An update of the cavity depth for MPPC64-PCB

7 December 2020

Request to update the cavity depth

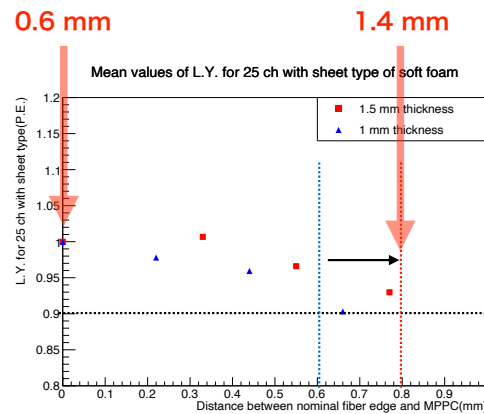
- In the current model, depth for the compressed soft foam is **0.7 mm** (= Cavity depth is 5.75 mm)

We request to update the thickness from 0.7 mm to **1.0 mm** (= Cavity depth is 6.05 mm), keeping G10 thickness.

Original : $0.86 + 4.2 + 0.7 = 5.76$ mm

Previous request : $0.86 + 4.2 + 1.0 = 6.06$ mm

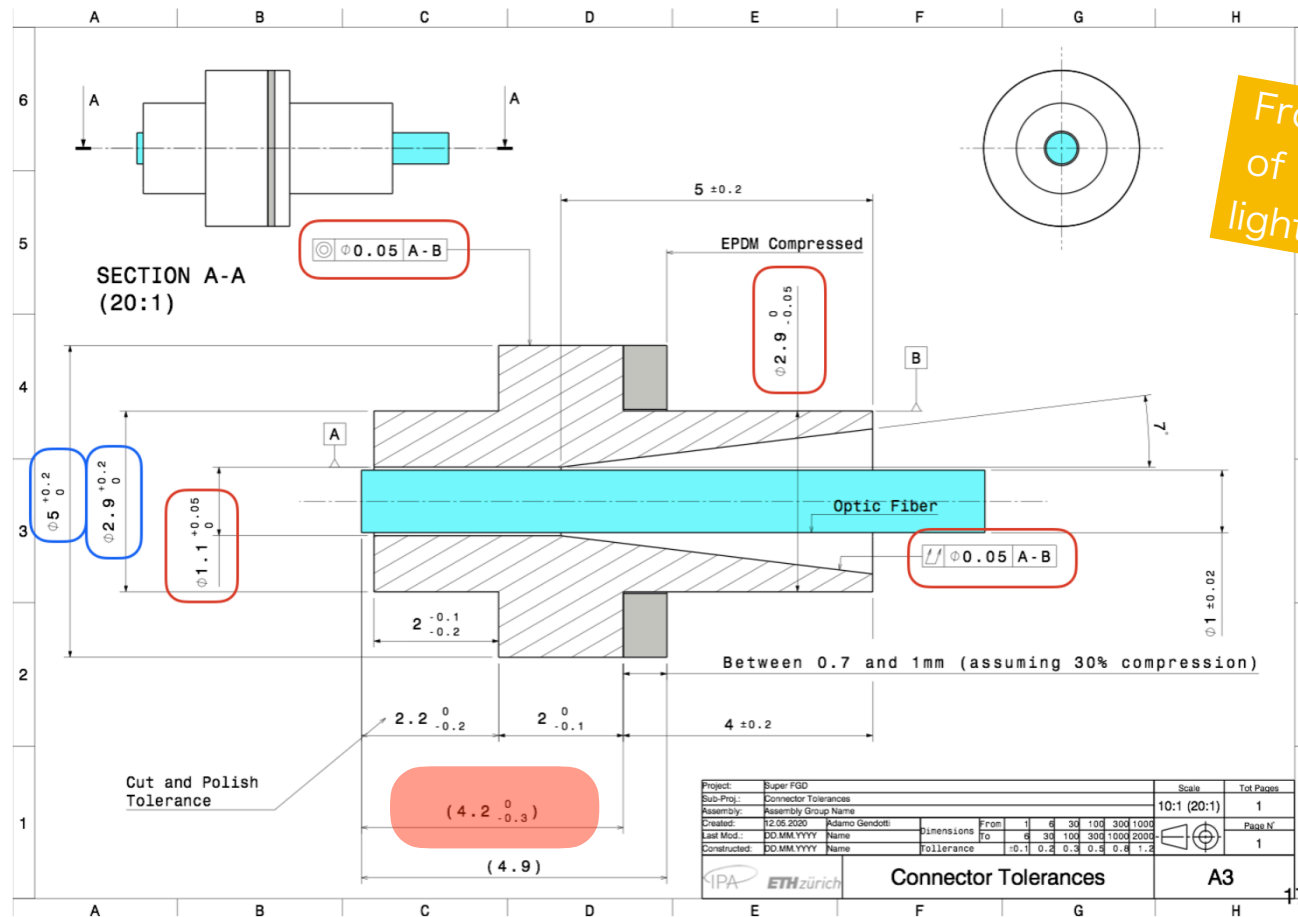
- We updated the thickness of soft foam from 1.0 mm to 1.5 mm for safety factor.
- [0.6, 1.4] mm is proper range of compressed thickness to provide good optical contacts.
- Center value of **1.0 mm** should be used for the thickness of the compressed soft foam.

Figure 7: 2D drawing of the optical connector with tolerances on the horizontal plane highlighted in red (critical) and in blue (non-critical). The MPPC sits on the left side of the connector, while the right side cylindrical part is inserted into the readout interface hole.

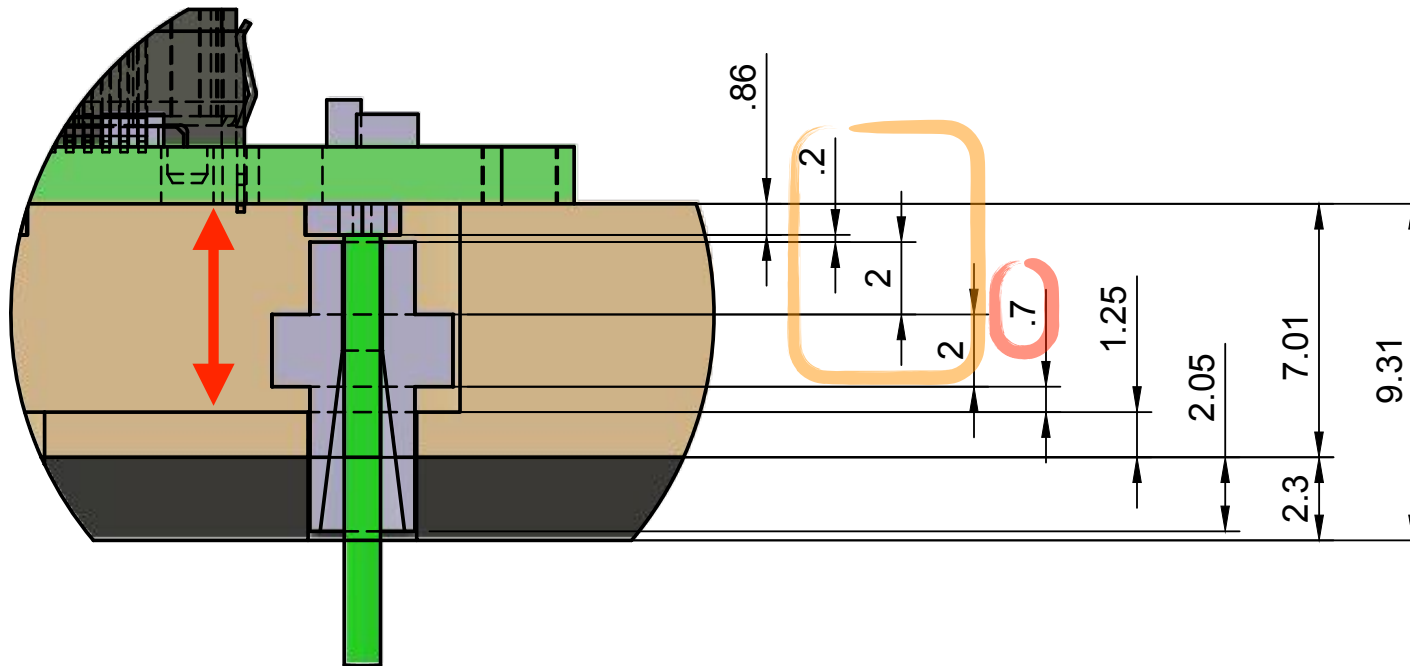
The negative tolerance ($4.2 +0 - 0.3$ mm) was not considered...
 → Mean value is 4.05 mm for both sided error (+/- 0.15 mm)
